Lahontan Regional Water Quality Control Board

RESPONSE TO AUGUST 14, 2013 SURFACE WATER DELINEATION WORK PLAN, ARIMOL GROUP, INC. AND MEADOWBROOK CEDAR, INC. PROPERTIES, LAKE ARROWHEAD, SAN BERNARDINO COUNTY, W DID NO. 6B36C363433

COMMENTS ON REVISED GRADING PLAN SUBMITTAL AND NOTICE OF CONTINUED VIOLATION OF CLEANUP AND ABATEMENT ORDER R6V-2012-0008, ARIMOL GROUP, INC., LAKE ARROWHEAD, SAN BERNARDINO COUNTY

RESCISSION OF LAHONTAN WATER BOARD APPROVAL TO PROCEED WITH PARTIAL CULVERT REMOVAL/SURFACE WATER RESTORATION PROJECT AND RESPONSE TO ARIMOL GRADING PLAN SUBMITTAL, ARIMOL GROUP, INC., LAKE ARROWHEAD, SAN BERNARDINO COUNTY, WDID NO. 6B36C363433

DATE	1958
PROJECT	MEADOWBROOK ROAD
SCALE	1" = 100'
PROJECTED AREA	1.5 AC.
OWNER	MR. & MRS. J. W. BROWN
ENGINEER	W. H. BROWN

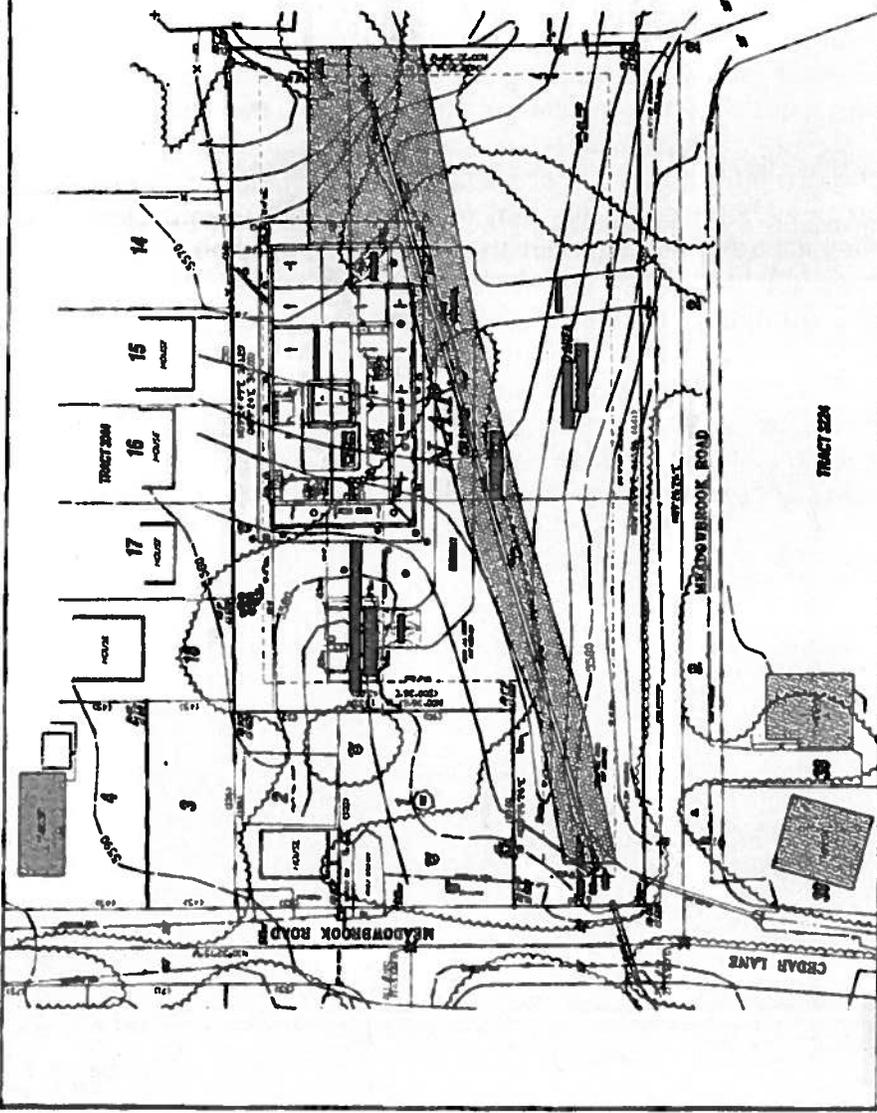
4. On October 17, 2011, Water Board staff received a complaint that the Discharger had filled a natural creek channel on the Site by placing a metal pipe culvert in the creek bed and burying the pipe with soil. See Attachment A (map of site).

SITE PLAN

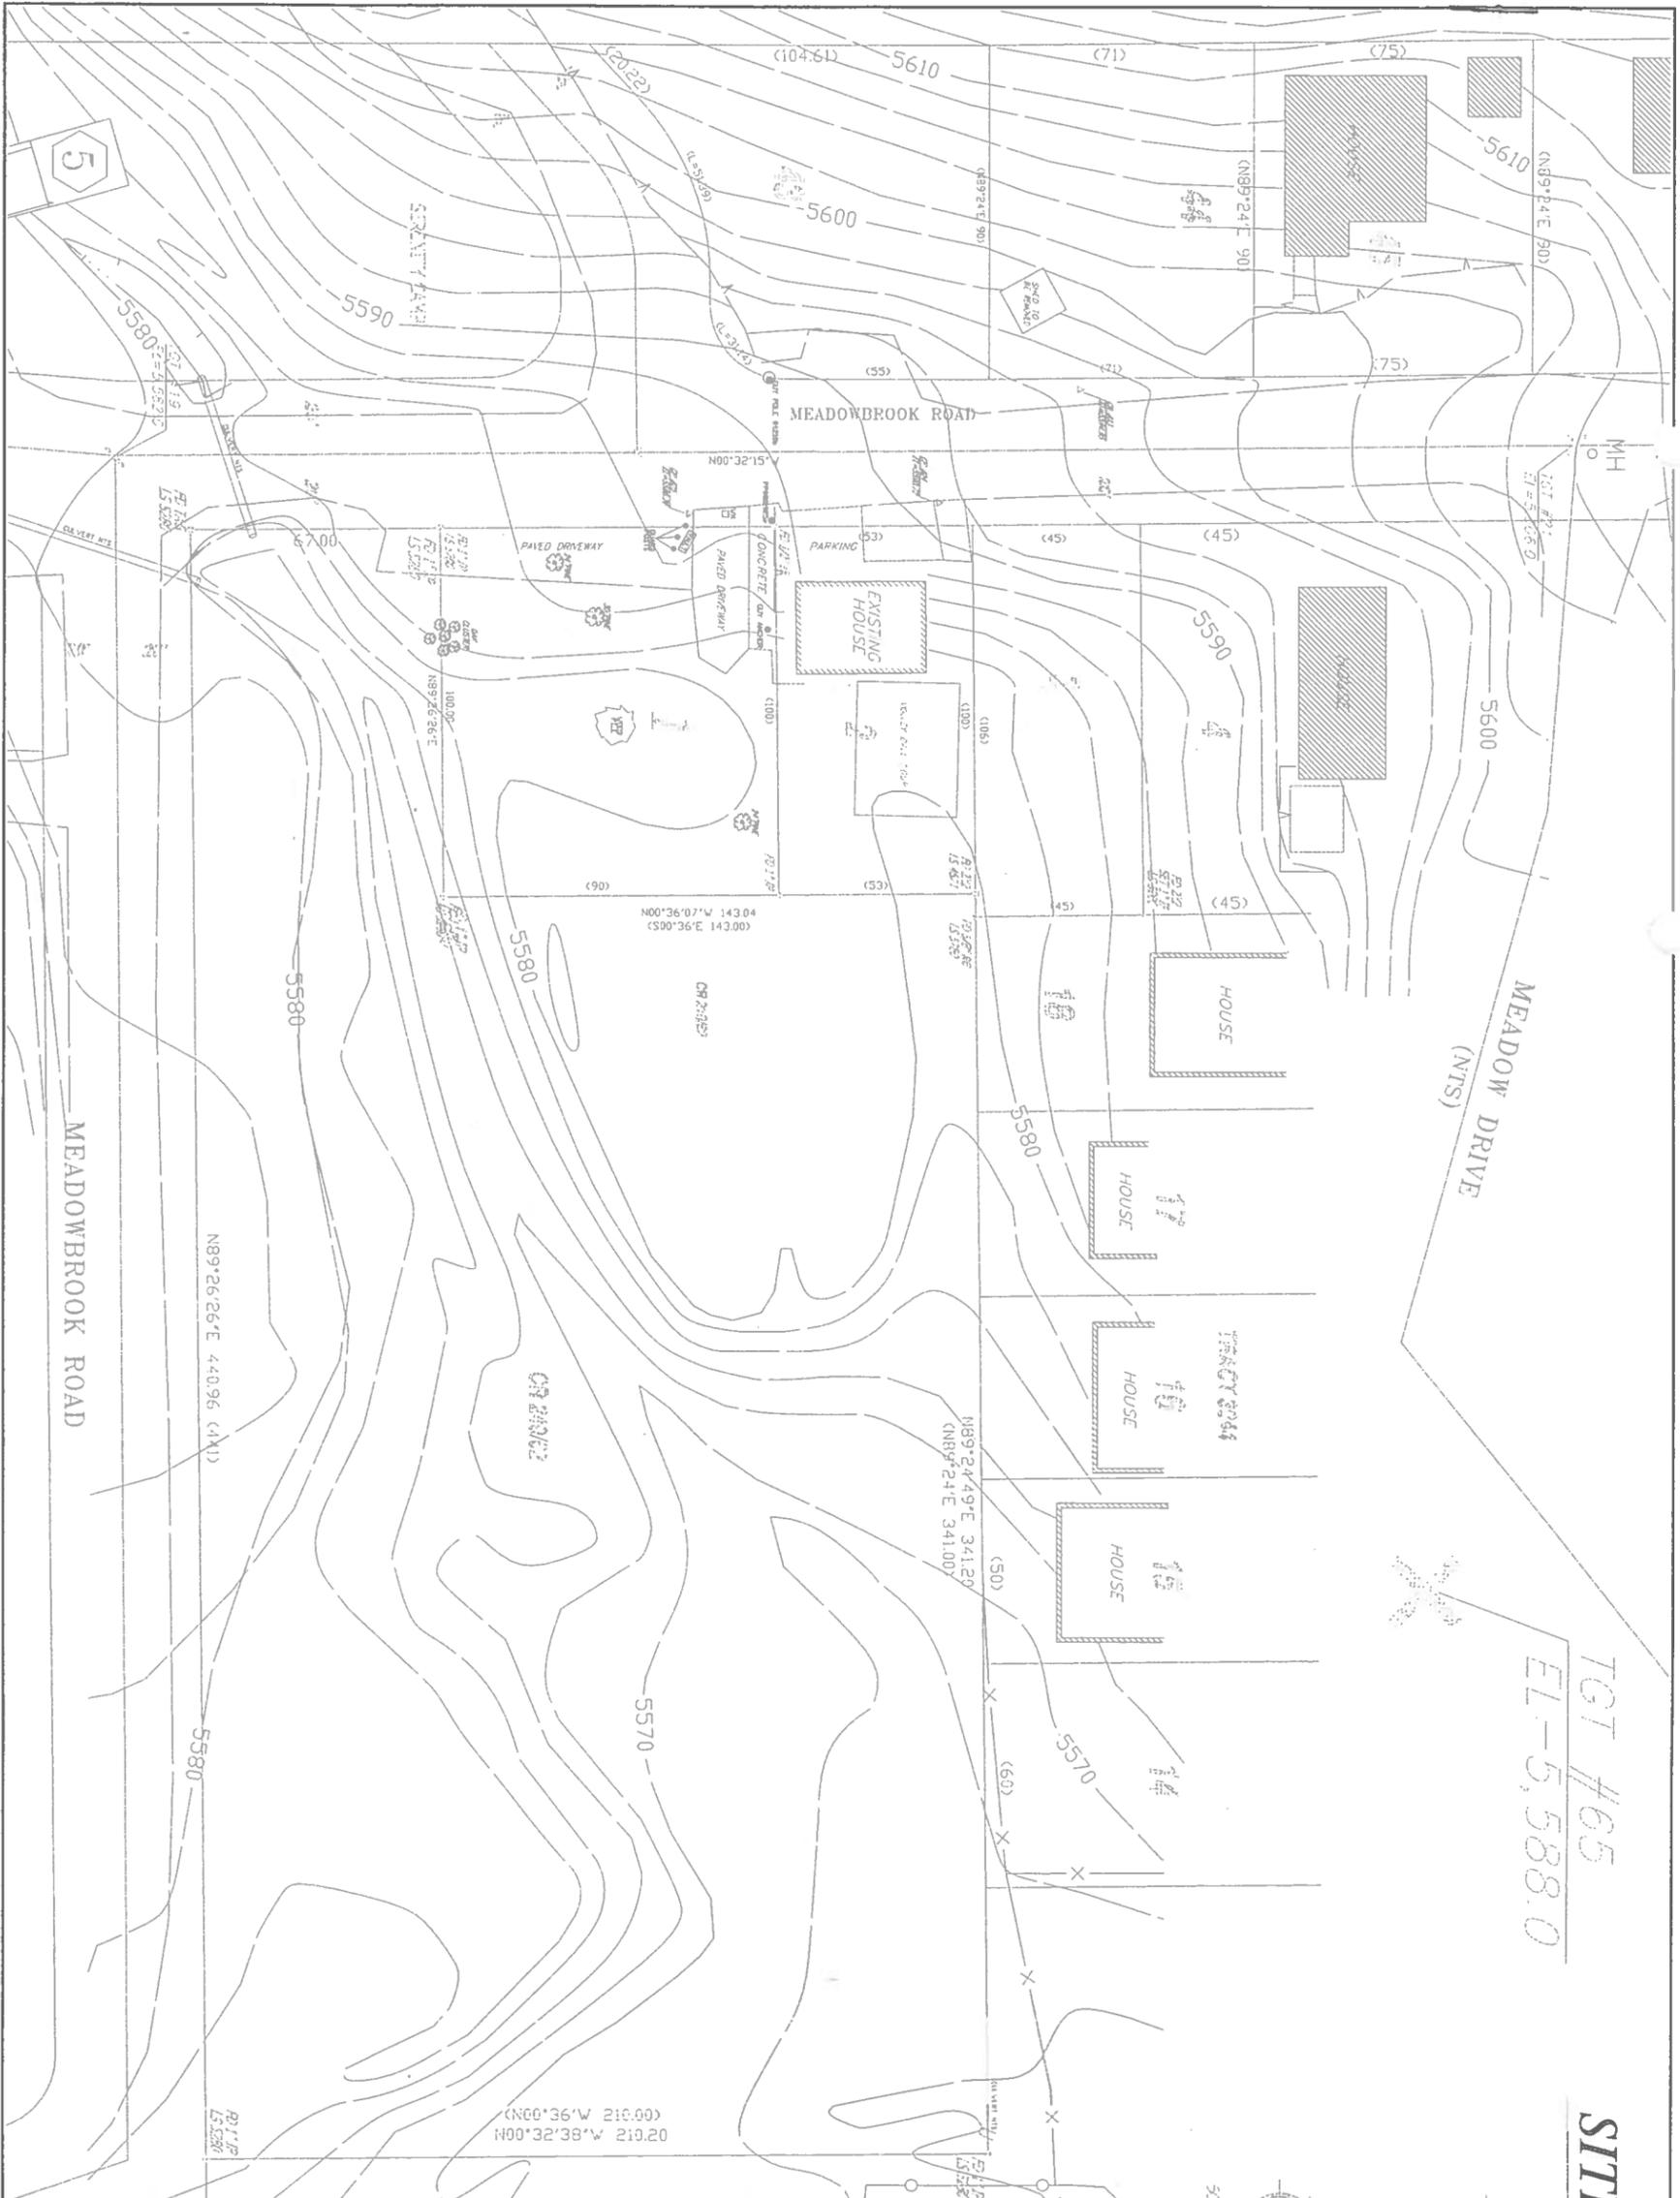
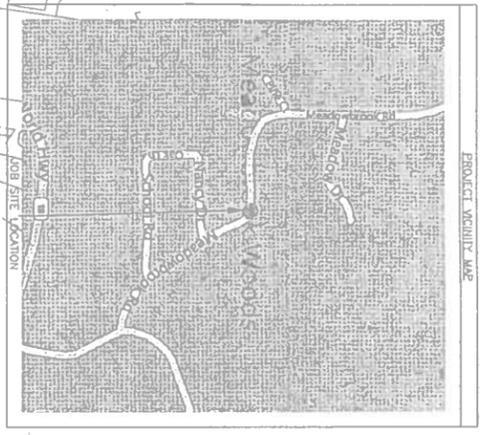
1. The Work Plan includes Figure 1 - Surveyed Topography. Figure 1 is presented as representing pre-project topographic conditions, based upon a topographic survey performed by Chris Ehe in September 2011. Water Board staff understands that Figure 1 is one of the several information sources used in developing the transect/plot layout shown in the Work Plan.

However, the topographic survey documents discussed in Enclosures 1 and 2 and shown in Enclosure 3, show topographic conditions, including surface water locations, differing from those shown in Figure 1. Water Board staff understands that some of the differences include depicting recently constructed structures and proposed restoration activities; however, such additions do not account for all of the differences Water Board staff has observed. Water Board staff has yet to determine which of the topographic survey documents purported to represent September 2011 conditions, accurately does so. Water Board staff wants you to be aware of this situation, since the Work Plan's transect/plot layout is likely based, in part, upon information provided in Figure 1, which may or may not accurately reflect September 2011 conditions.

One example of such differences is the topographic contours depicted in the southeast quadrant of Figure 1 and the topographic survey document provided in Enclosure 3. Another example is that Figure 1 shows the locations of the south and north springs, while the topographic survey document provided in Enclosure 3 does not. There are likely other differences between these and other survey documents purported to represent September 2011 conditions.

The topography shown on sheet C-1, Site Plan, is significantly different from the topography shown on all previous plans and drawings submitted to the Water Board. The Surveyor's Statement, listed in the lower right hand corner of sheet C-1, states that the topography shown was accurate as of September 2011, and represents the historic topographic contour of the Site prior to commencing ground disturbance activities in October 2011. Please explain the inconsistency in plan topography between this sheet and other plan sheets previously submitted to the Water Board, and verify whether or not the topographic survey as shown on this plan sheet accurately depicts the historical topography of the site in September 2011.

- d. Historical topographic contours, as shown on the, sheet C-1, Site Plan, must be used as a base for determining historic extent of surface water features on the Site. For example, based on topographic contours as shown on sheet C-1, it appears that the wet meadow area in the eastern portion of the Site likely extended much farther to the south than what is currently shown on sheet C-2, Streambed Grading Plan.

Lahontan Water Board staff has observed that the topographic contour lines shown on Plan Sheet No. C-1 (Site Plan) are noticeably different from those shown on Plan Sheets No. C-2 through No. C-4, which runs contrary to the Surveyor's Statement repeated on all four plan sheets. The discrepancies cannot be accounted for by changes in scale, as the scale is consistently noted to be 1 inch = 20 feet on all four plan sheets.

Extend the eastern-most two transects shown in Work Plan Figure 3 to the southern property boundary, adding additional plots to account for the differing topographic contour representations shown for the southeast quadrant of the 1.8-acre parcel. Identify any additional transect/plot modifications you are incorporating into the final Work Plan to account for other inconsistencies between differing topographic survey documents purported to represent September 2011 conditions.

Required Action: Future submittals will need to clearly and accurately identify the source of/basis of information shown on all plans.
